Glennstone Phase 3 Dry Pond 3

(City of Durham ID# 00410)

Annual Certification Inspection Journal (ACIJ) – Interim Report

TRAC-2020-07-01

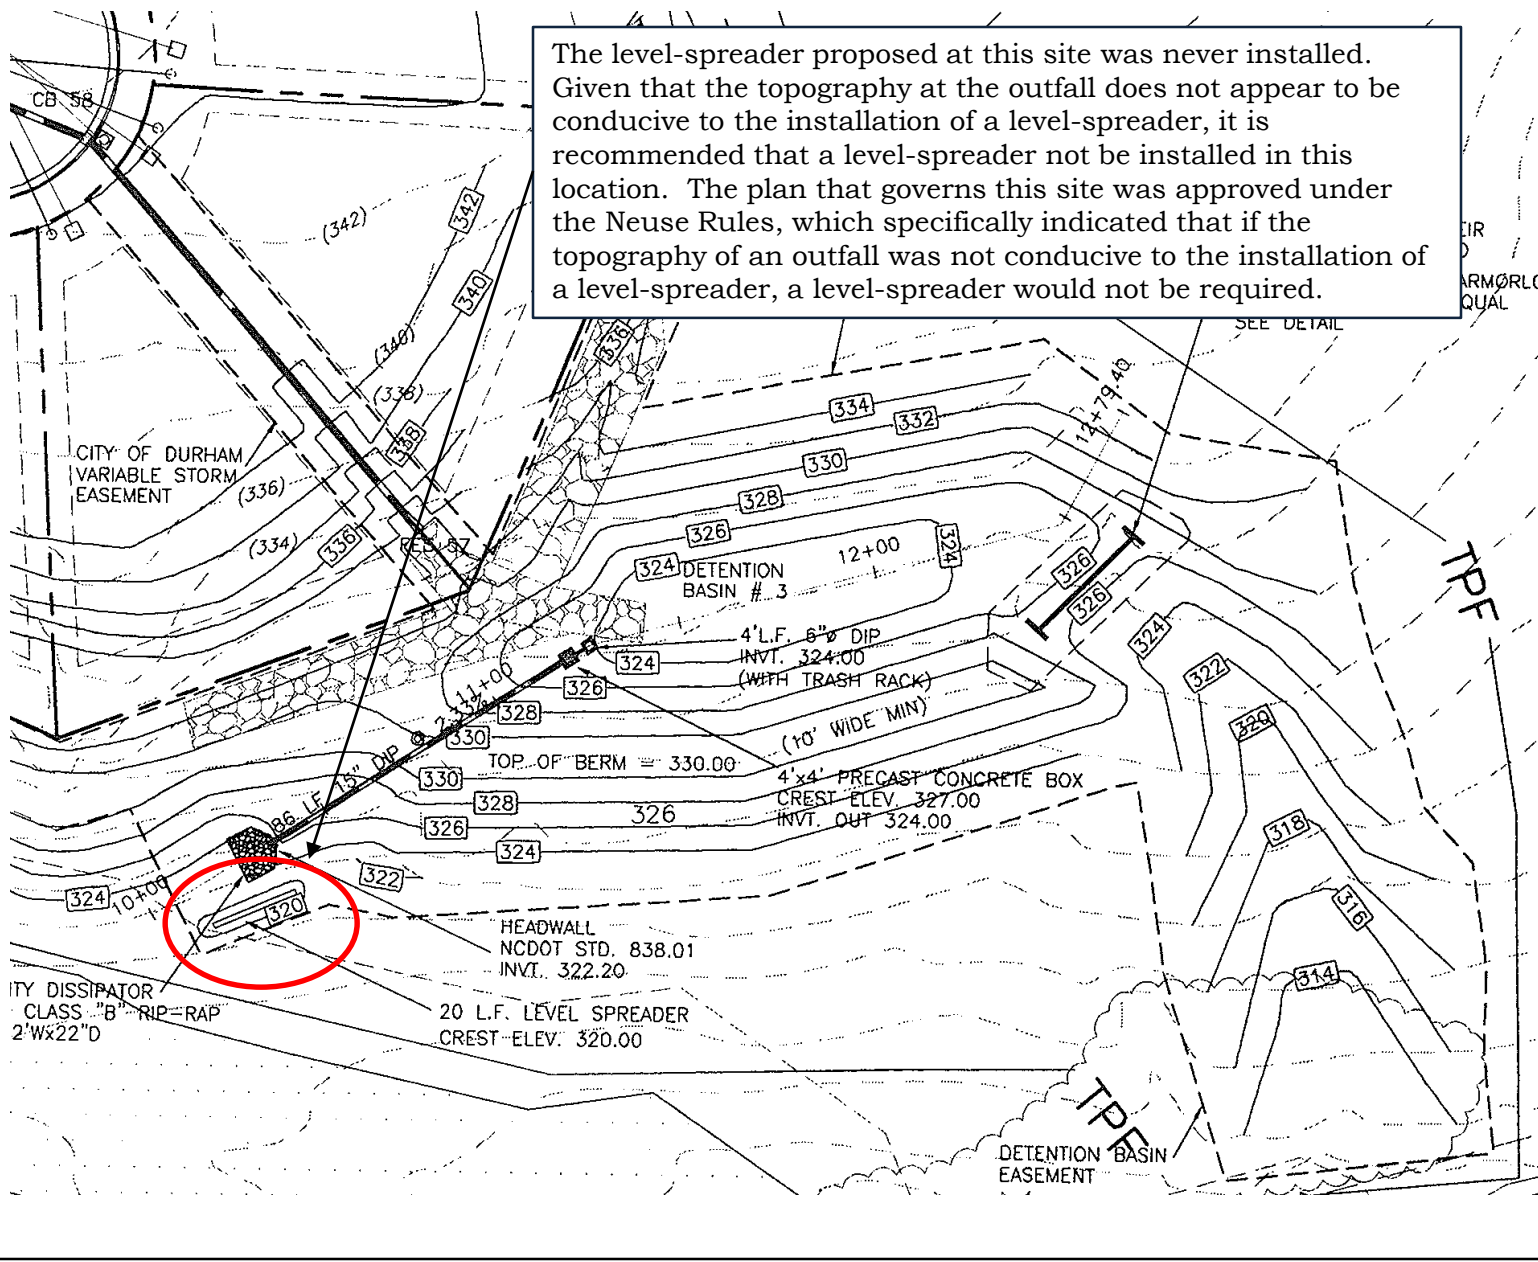
The level-spreader proposed at this site was never installed. Given that the topography at the outfall does not appear to be conducive to the installation of a level-spreader, it is recommended that a level-spreader not be installed in this location. The plan that governs this site was approved under the Neuse Rules, which specifically indicated that if the topography of an outfall was not conducive to the installation of a level-spreader, a level-spreader would not be required.
